## MEMORANDUM – PLAN & DESIGN COMMISSION

**TO:** Plan and Design Commission (“*Commission*”)  
**FROM:** Community Development Department  
**DATE:** for the June 2<sup>nd</sup>, 2026 Commission meeting  
**RE:** **DES-2026-00096, Design Review, Sign Package, and Variations from the City Code (791-799 Central Ave.)**

## **799 Central Narrative for Highland Park Design Review Application | 06.02.26**

# MEMORANDUM – PLAN & DESIGN COMMISSION

SHEET INDEX

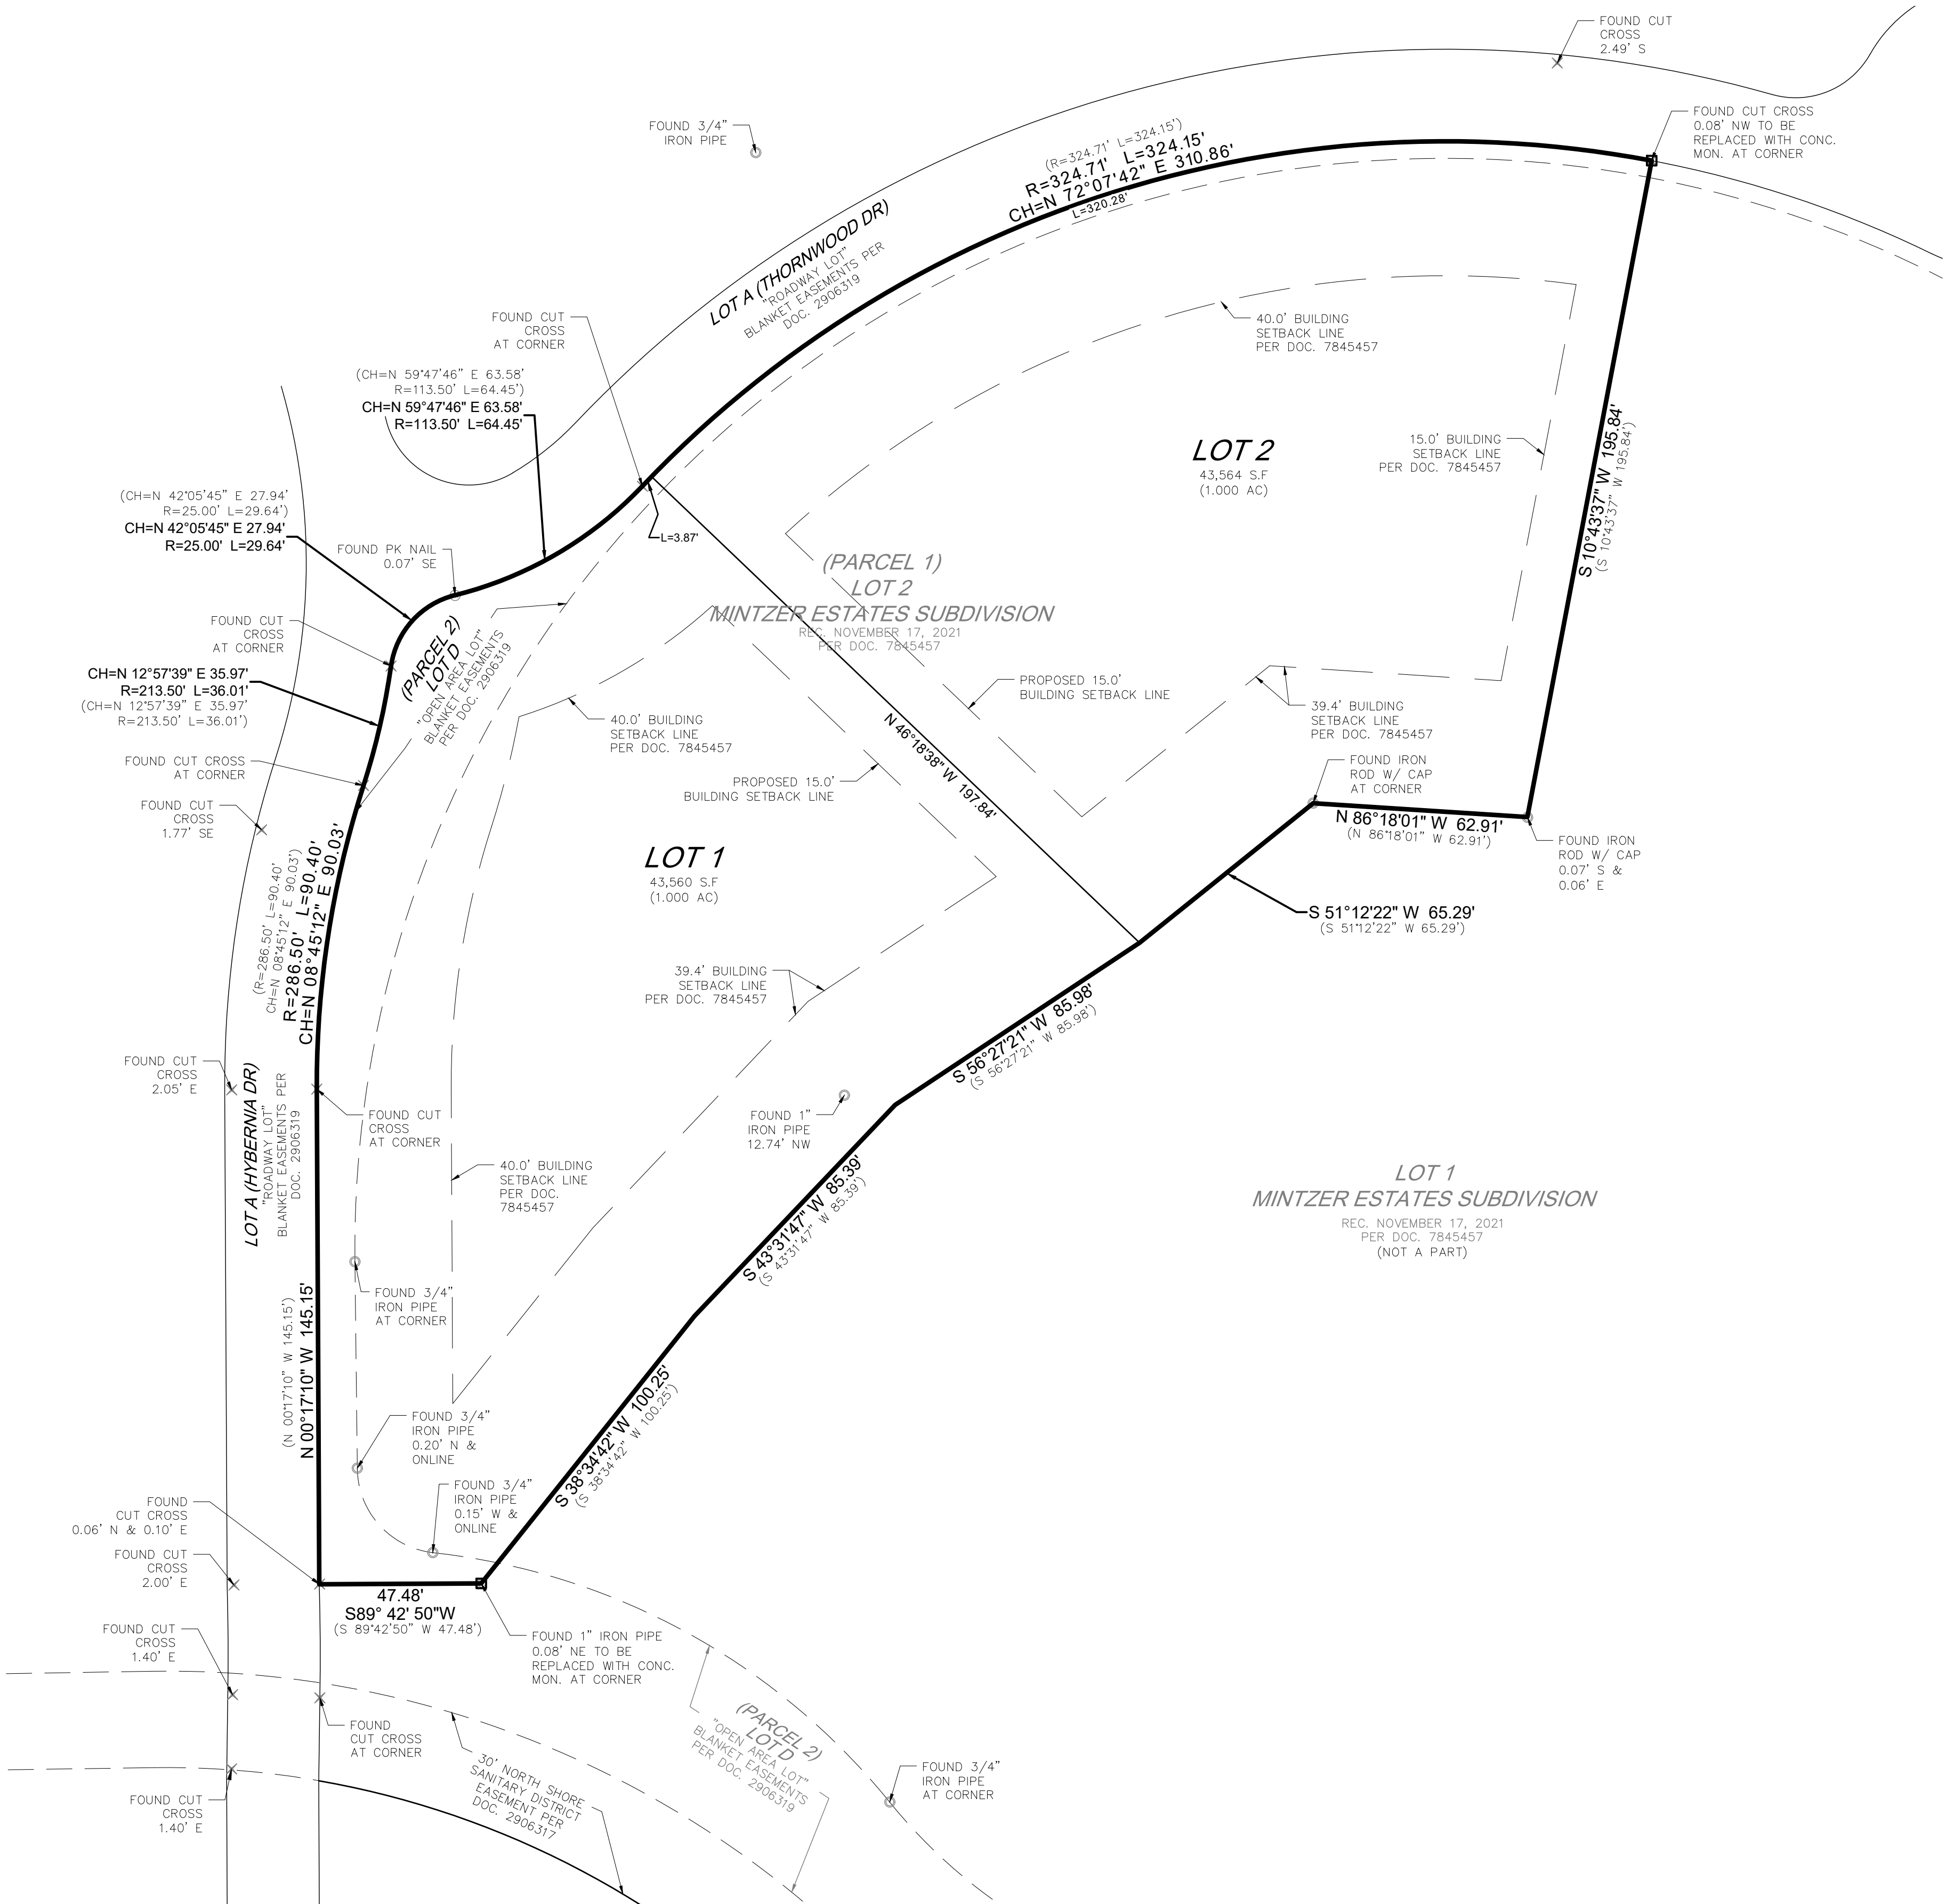
1. Planning Comments:
  - a. Zoning review is included within this memo.
2. Engineering Comments:
  - a. In current conditions the lots drain east so with the new lot lines Lot 2 will need to accept the Lot 1 run off.

4. Fire Departments: No objections.
5. Building Division: No objections.
6. ComEd: The only comment ComEd has is that the Easement Provisions from Document 2906319 referenced on this new Plat should be included. Alternatively, the attached easement provisions can be added. (See **Attachment 7.**)

- d. Subdivision Building Lines appear on the plat. The Codes does not require these lines. The Applicant may remove them if they want. If the Applicant keeps the lines they should clarify what accessory structures are allowed to encroach, such as fences.

- A. The Owners shall secure the necessary approvals from all public utility companies, provide easement statements, and locate all existing easements on the Plat, prior to recordation.
- B. The Owners shall secure the signature of the City Engineer and that of the County Clerk on the Plat, prior to its recordation.
- C. The Plat shall include all certificates, signatures, and seals as required by Section 151.005(A)(12) of “The Highland Park Code of 1968,” as amended.
- D. The Plat shall identify monuments for all corners of the proposed lot.
